Former Dunham Bush Site

RE: Former Dunham Bush Site, Downley Road, Havant – Technical Note

Re: APP/24/00606 At 8 Downley Road, Havant, PO9 2JD

Figure 2-1 Location of Speed Survey 1**Figure 2-2 Location of Speed Survey 2**

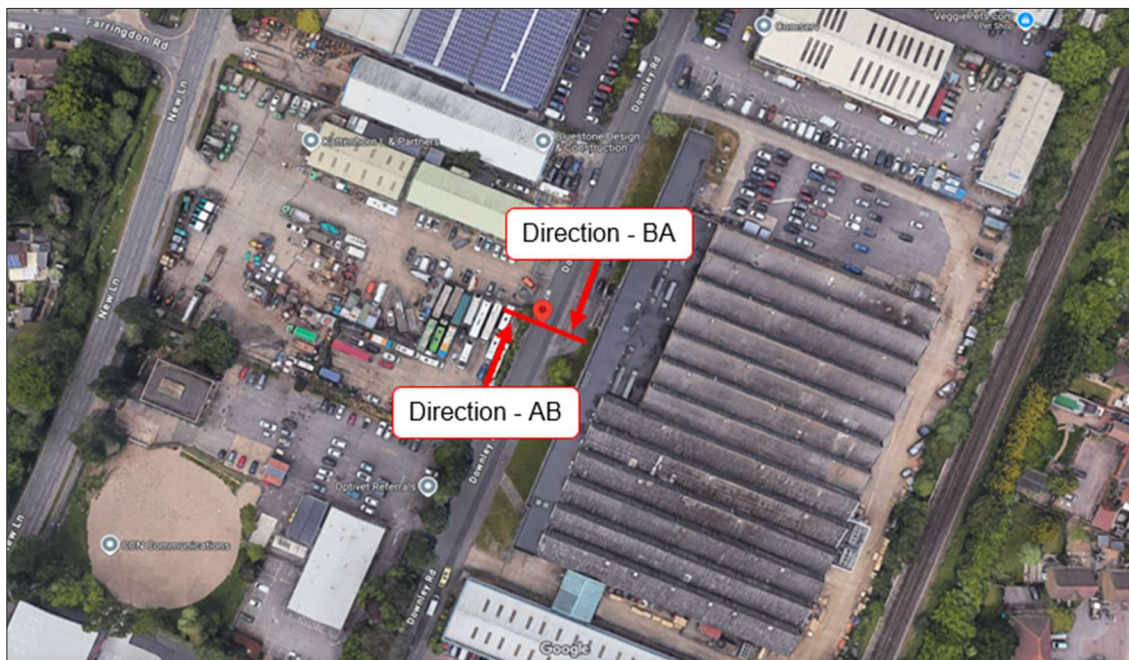
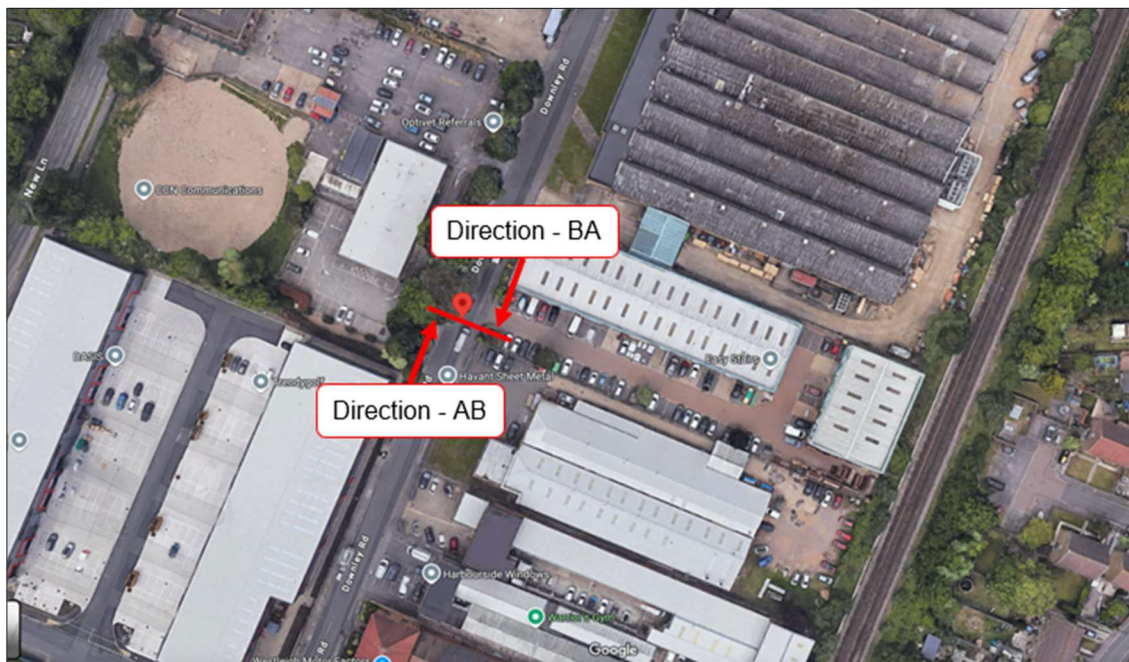
HCC say that “the submitted Technical Note (TN) states that the proposed site access junction visibility splays are 2.4m x 61m to the left and 2.4m x 120m to the right. The TN states that the splays exceed the minimum requirements outlined in Manual for Streets for a design speed of 37 mph, which is 59m. It also references Hampshire County Council’s TG3 guidance, which requires visibility splays to be based on recorded 85th percentile speeds. However, the TN considers it unlikely that speeds will exceed 37 mph on this section of Downley Road, given the 30 mph (48 kph) posted speed limit and the road’s nature as a dead-end route. Consequently, the note concludes that the proposed visibility splays are generous and appropriate for the type of road and anticipated traffic conditions. This position is not accepted by the Highway Authority and the need for speed surveys has been made clear since the pre-application stage”.

2. Speed surveys have been carried out for the week commencing 16th December 2024 and will be surveyed again the week commencing January 6th January 2025 as agreed with HBC on 12th December 2024. They have been carried out at two locations which coincide with the visibility splay for 30 mph which is the posted speed limit of Downley Road. Locations are shown on **Figure 2-1** and **2-2** below.

3. The results for the December surveys have been returned and the 85th percentile speeds are summarised below. The January results will be forwarded as soon as they have been returned from the survey company.

4. The results show that the 85th percentile speed along Downley Road for both directions and Sites recorded is 30mph or lower. This demonstrates that the visibility being provided for the redesigned Site access meets the HCC design standards.

Figure 2-3 HGV Waiting at Pedestrian Crossing

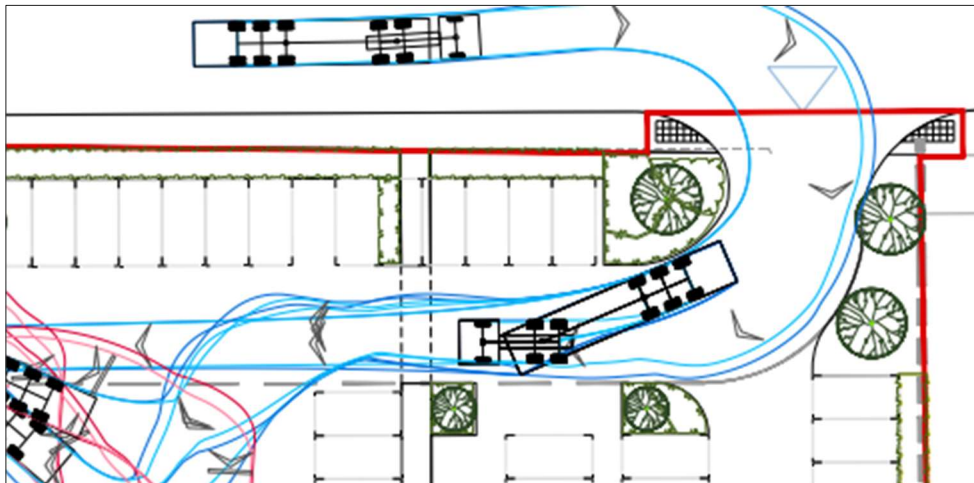
HCC say that *“The proposed access plans do not appear to show any pedestrian crossing facilities. The proposed bellmouth arrangements should include the provision of dropped kerbs with tactile paving, to facilitate inclusive crossing facilities across the site access arrangements for all users. All dropped kerb crossing points should be supported by TG3 compliant pedestrian visibility splays”*.

5. The proposed site layout plan has been revised so that it includes tactile paving and dropped kerbs at both site accesses. They are also included on SLR drawing 425.065366.00001_AT_SK04 Rev B which shows the proposed site accesses. Copies of both drawings are included at **Appendix B**.
6. **Figure 2-3** shows the position of the pedestrian crossing locations within the Site, as well as demonstrating that an HGV is able to wait within the Site while someone crosses.

Drawing Title
Swept Path Analysis - Fire Tender
Site Access

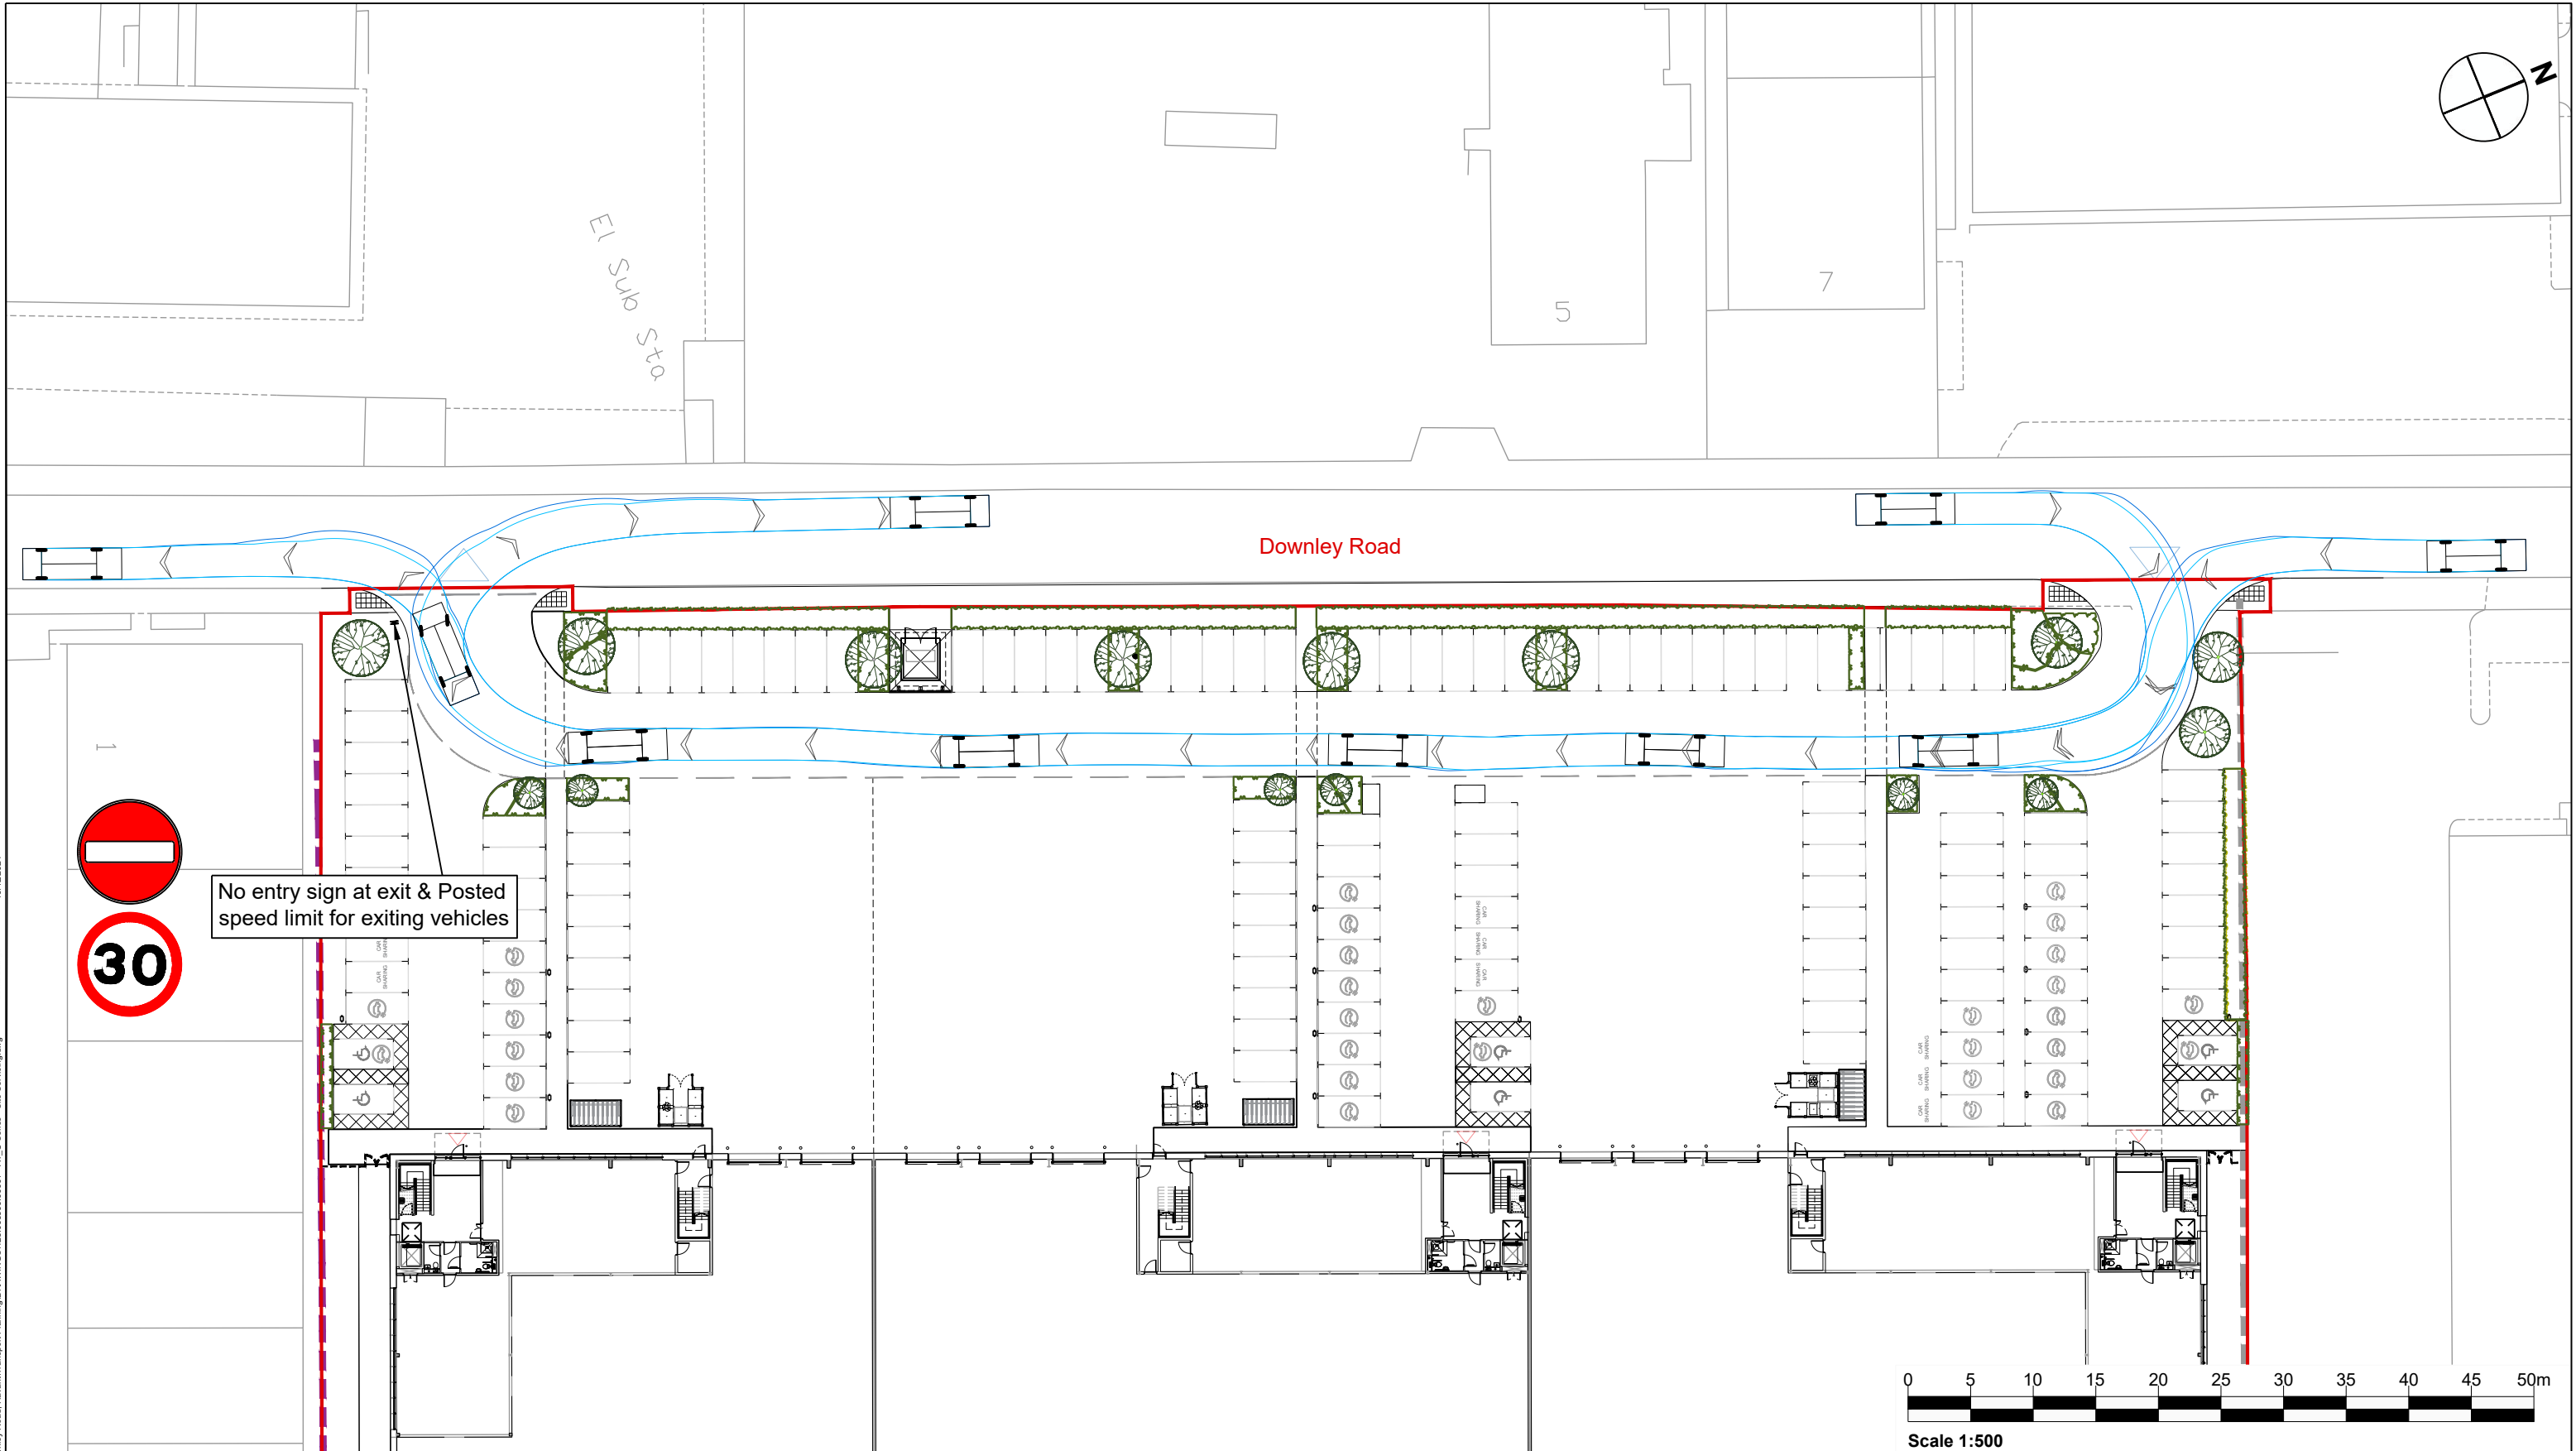
HCC say that “A fire tender swept path analysis in accordance with TG2 is as required under building regs and has not been provided for review. This should be provided for consideration”.

8. A fire tender tracking has been provided on drawing 425.065366.00001_AT_C03 and is included in **Appendix B**.
